Notice of Alteration Request

RE: Notice of Alteration Request – Diageo Gimli Plant

This notice of Request for Alteration is submitted to Manitoba Conservation on behalf of the Diageo Gimli Plant. This request is to incorporate an alteration to the process flow of the Diageo Gimli Wastewater Treatment Plant into the environment act licence currently under development. The alteration requested in this letter would allow the Diageo Plant to pump wastewater to the R.M. of Gimli's Wastewater Treatment Plant. The resultant process alterations will be located on land currently owned and operated by Diageo Canada Inc.

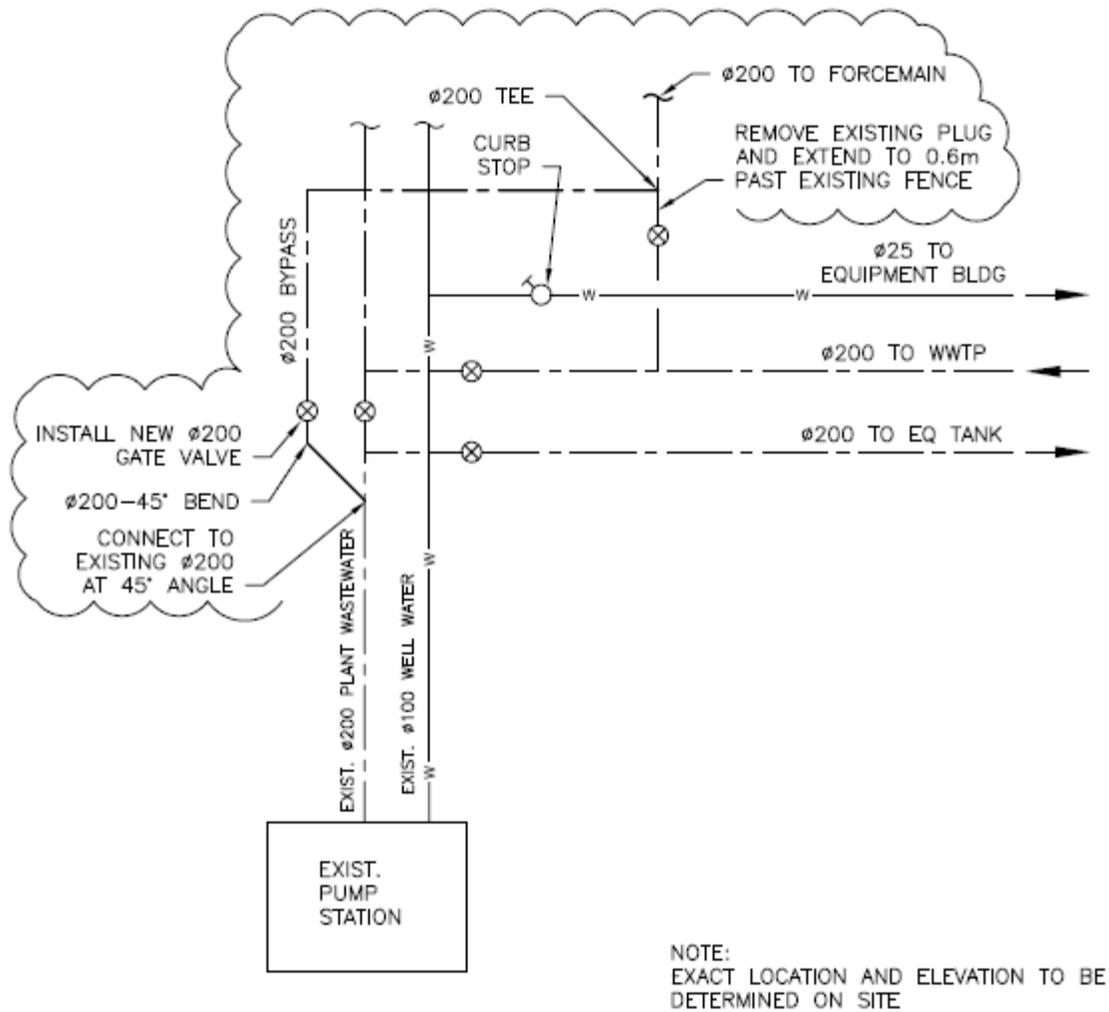
Under the previously submitted notice of alteration (dated July 08, 2015), the process consisted of influent raw wastewater pumped from the Lift Station to the 1,275 m³ equalization basin currently under construction. Wastewater then flowed by gravity to the Diageo Gimli Wastewater Treatment Plant (Diageo WWTP).

Diageo has entered into a three year agreement to send wastewater from the Diageo Gimli Plant to the R.M. of Gimli's Wastewater Treatment Plant (Gimli WWTP) via a newly constructed forcemain. The new equalization tank will equalize the flow while sending Diageo's wastewater to the Gimli WWTP, and several modifications to the previously described system would be required to allow consistent flows.

Figure 2: Connection Detail

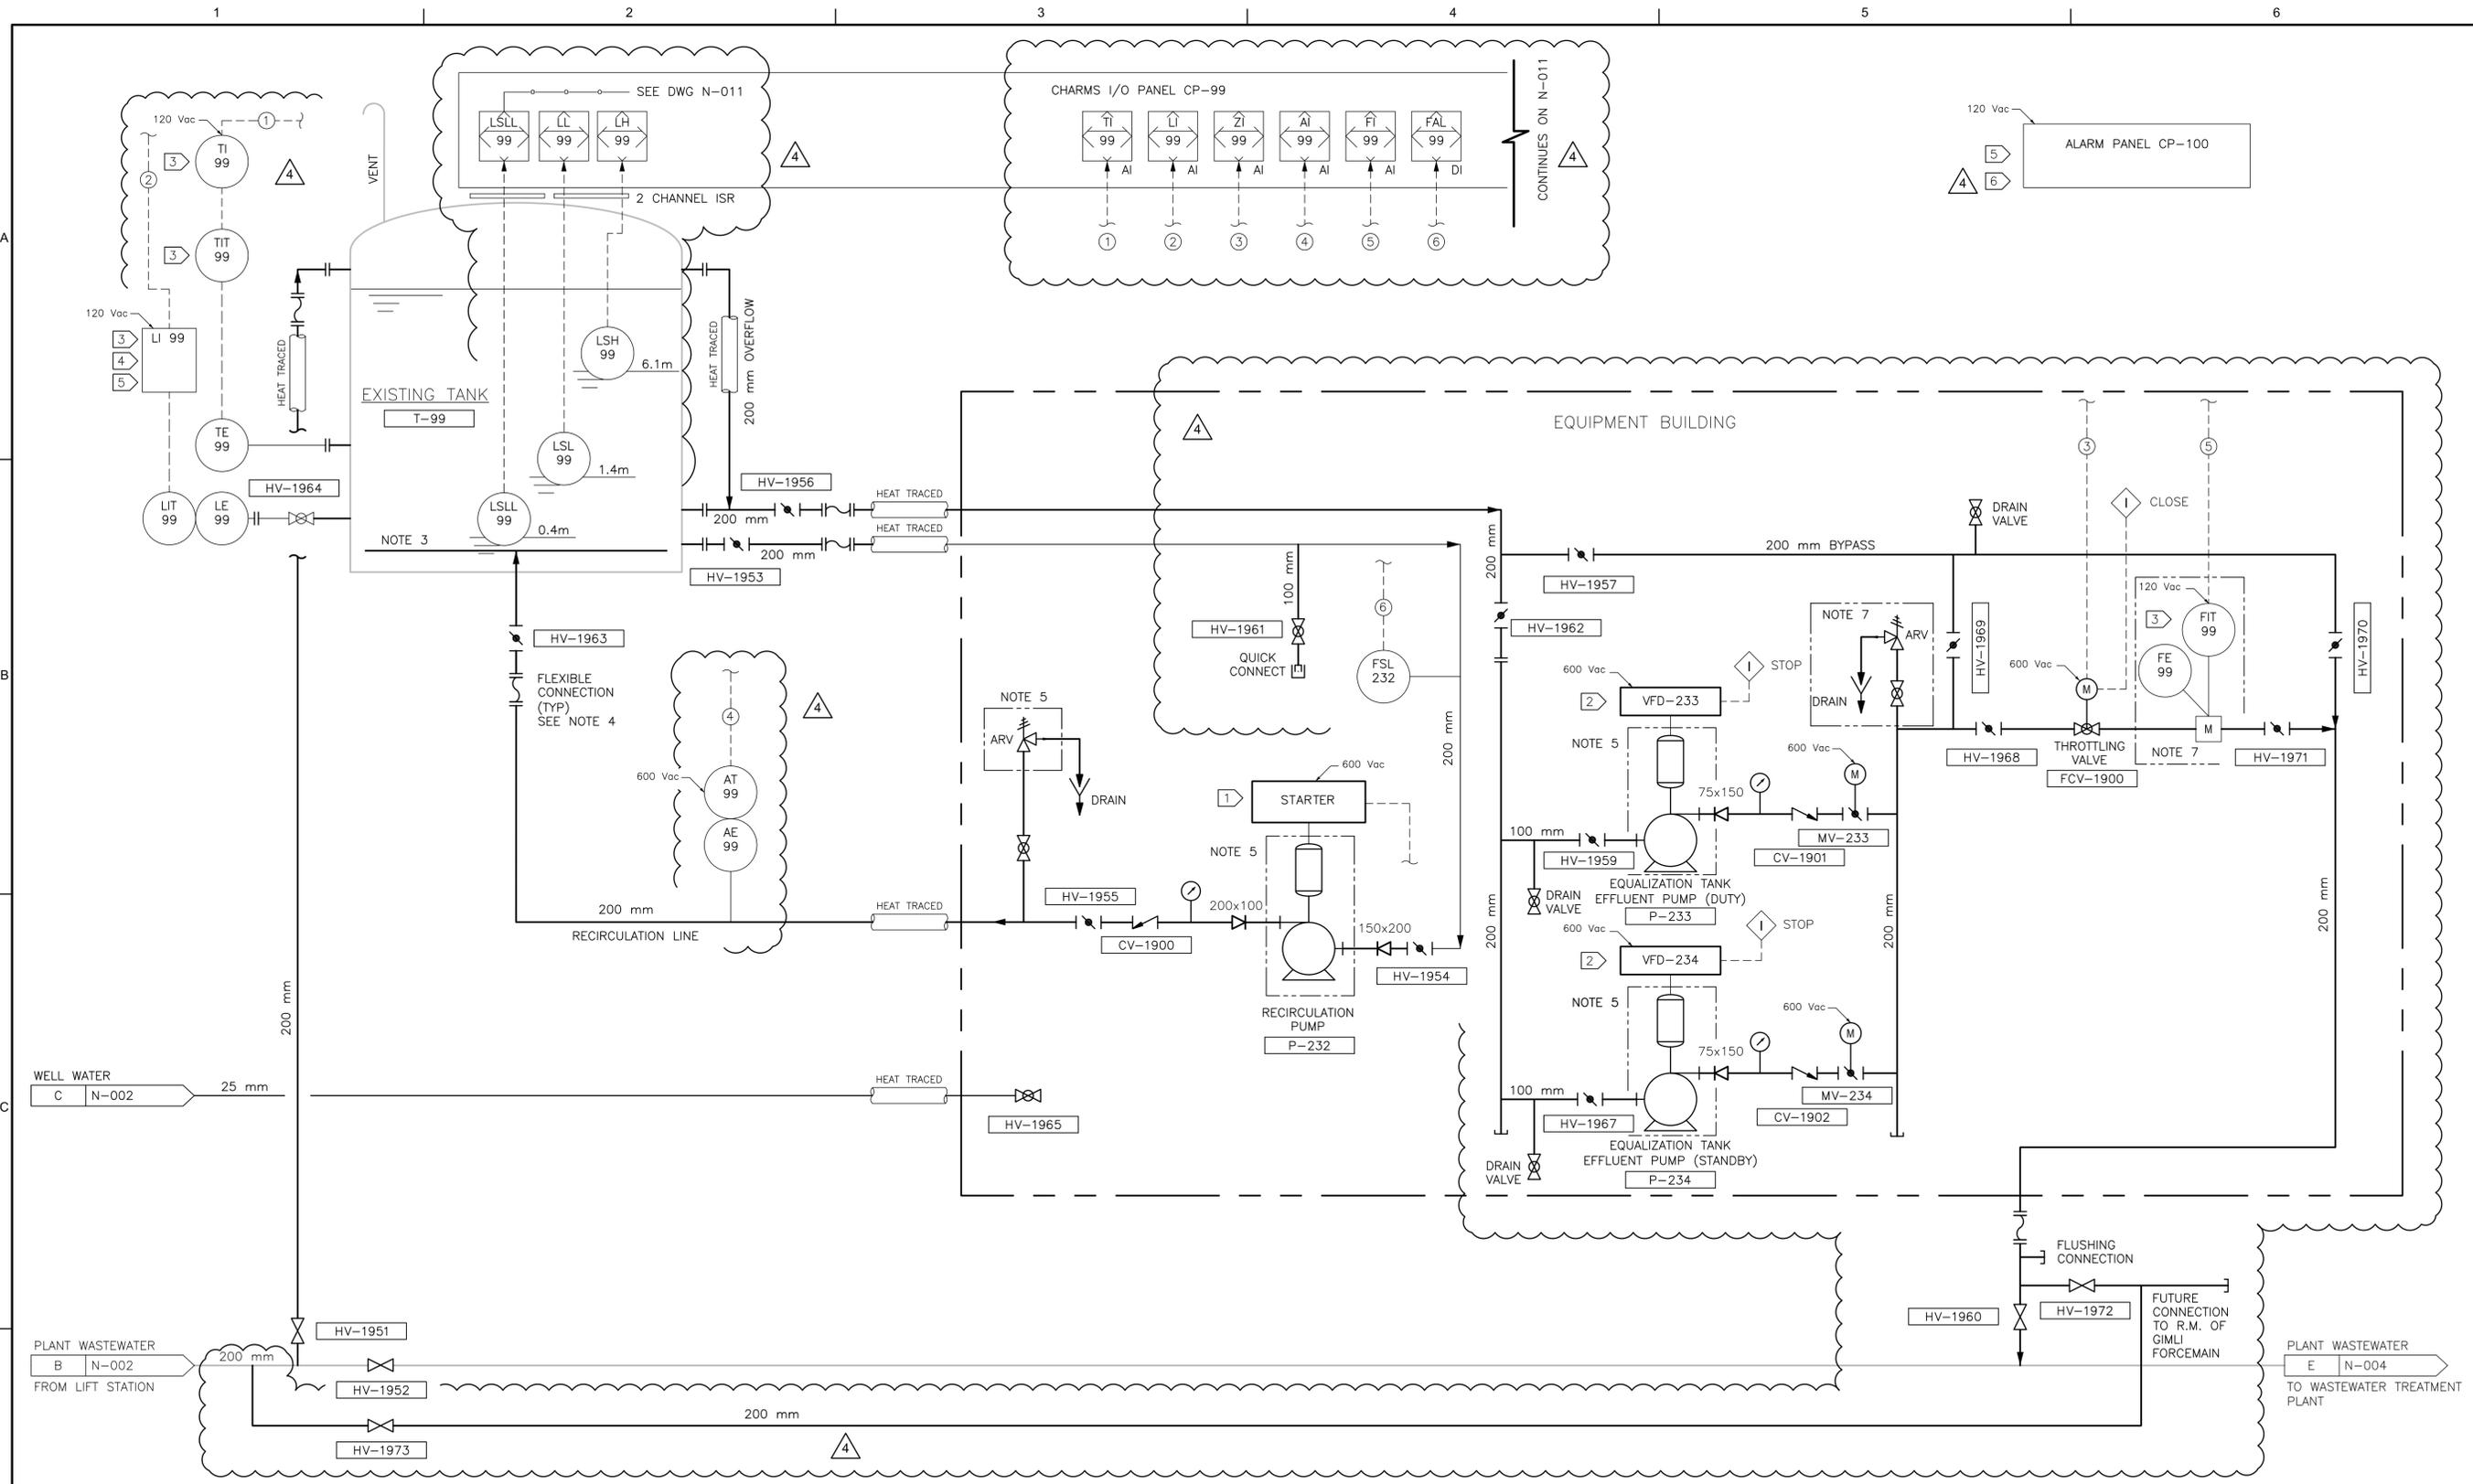
The proposed alteration will send wastewater from Diageo's equalization tank to Gimli's wastewater collection forcemain, from where it flows to the Gimli WWTP.

The existing pipe between the equalization tank and the Diageo WWTP plant wastewater line will be reused, with the isolation valve on the 200 mm effluent line from the equalization tank closed to prevent flow to the Diageo WWTP and redirect flow to the new forcemain. A new 200 mm stainless steel pipe and isolation valve will be connected to the equalization tank effluent pipe, and this new 200 mm stainless steel pipe will extend from the effluent line north to the Gimli forcemain. A new 200 mm stainless steel equalization system bypass
